# Maule Aircraft Corporation

## SERVICE LETTER #46

SUBJECT: New Flap Ratchet.

AIRCRAFT AFFECTED: MAULE Model M-5-210C, Ser. No. 6001C thru 6206C.

SERVICE LETTER # 46  
INSTALLATION INSTRUCTIONS

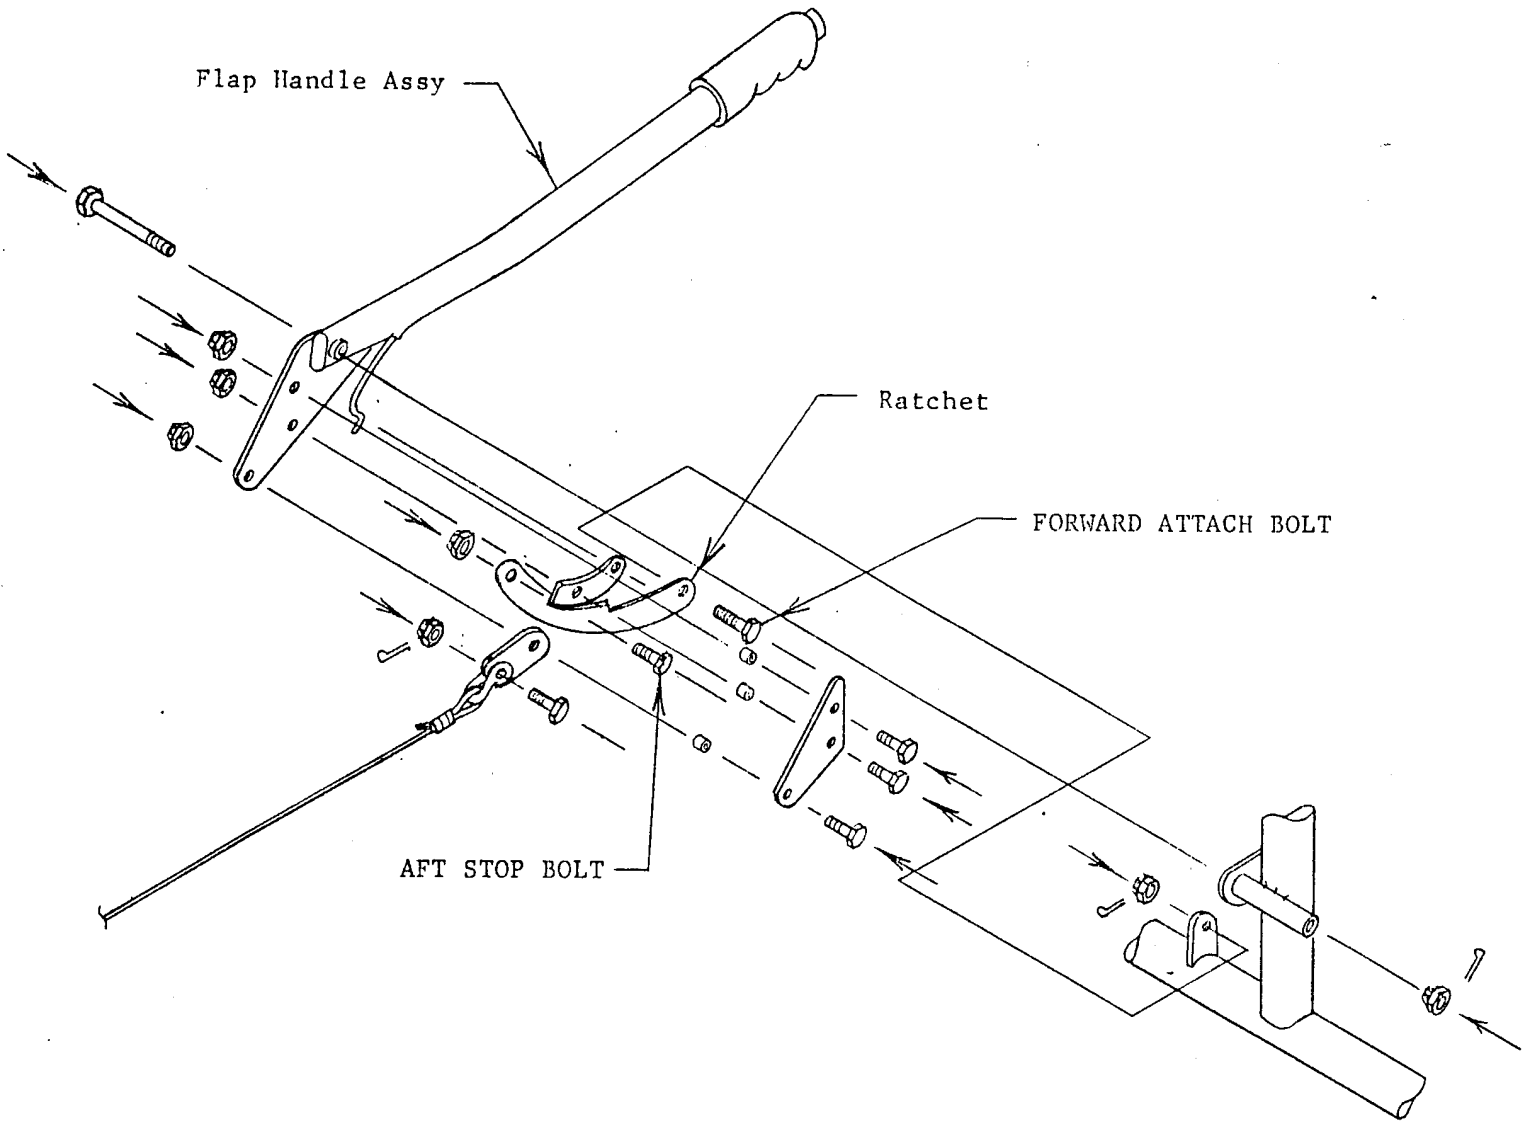
BACKGROUND: Many MAULE owners have requested increased flap travel for their airplanes. The new flap ratchet allows 5° - 8° more travel at each setting. There is also available an alternate lever which is bent upward. This allows more clearance under the lever for easier grasping. Either unit can be used separately.

1. Remove left front seat.
2. Remove control cover (ref. Item 6, Group C-4 of Parts Catalog)
3. Remove old ratchet:
  - (a) Remove forward ratchet attach bolt and nut.

- (b) Remove aft stop bolt and nut.
  - (c) Slide ratchet forward thru plates of flap handle assembly.
4. Install new ratchet:
  - (a) Slide ratchet aft thru plates of flap handle assembly.

- (b) Install forward attach bolt and nut and secure with cotter pin.
  - (c) Install aft stop bolt and nut removed from old ratchet.  
NOTE: 20°-40° ratchet has forward stop bolt and nut deleted.

- (1) Flap Ratchet p/n 3207B
- (1) Alternate Flap Lever Assembly p/n 3058F-28 (opt.)
- (1) Flap Handle Placard (20°-40°)
- (1) Installation Sketch
